Technical Service Bulletin (TSB) - VR1J45GGRJY057489	
D5BW0120Q0 : Version 0 of 09/07/2019	
FOR : DS 7 CROSSBACK (X74) AND RIGHT HAND DRIVE UNTIL RPO 15513	
CUSTOMER SYMPTOM :	BLEMISH VISIBLE ON THE INSTRUMENT PANEL AND THE DS LOGO IS NOT DISPLAYED
CONDITIONS IN WHICH FAULT APPEARS :	WHEN OPENING THE DRIVER'S DOOR OR WHEN THE IGNITION IS SWITCHED OFF

Figure : D5BW00PD

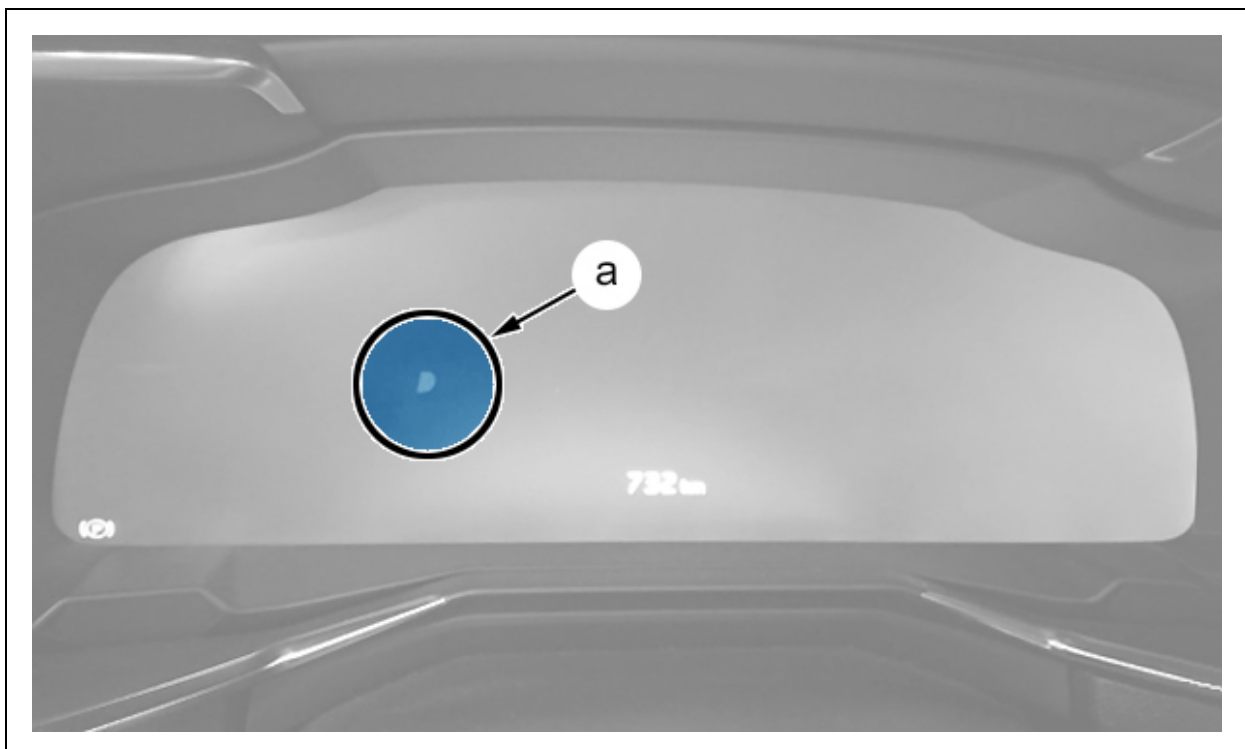
When the ignition is switched on or off, check if there is a blemish (spot) on the instrument panel (at "a") :

- If there is a blemish (spot) on the instrument panel : Carry out repair
- If there is no blemish (spot) on the instrument panel : Do not apply this document ; Carry out in-depth fault finding
